## Product Change Notice (PCN)

**PCN Number:** PCN-0455011R-01

Product(s) Affected: *SJ-3523-SMT-TR & SJ-3524-SMT-TR*

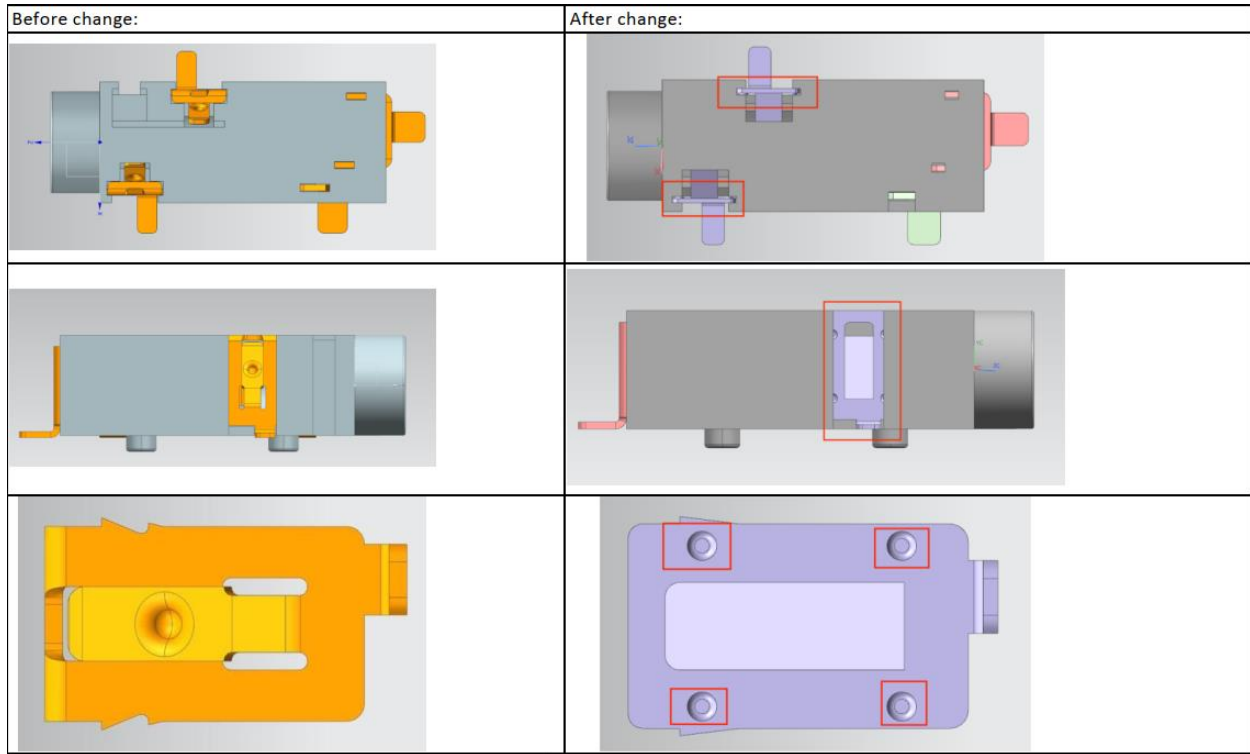
- 1) Removal of additional slots in the base. Plastic structural change.
- 2) Hardware/Shielding adjustment.
- 3) Terminal 4 material change to Brass.

No Change to PCB Footprint

See image below for reference and check Same Sky website for updated drawing on or after **12/10/2024**. Cosmetic differences may be visible due to new molds and not affect the form fit and function of the product.
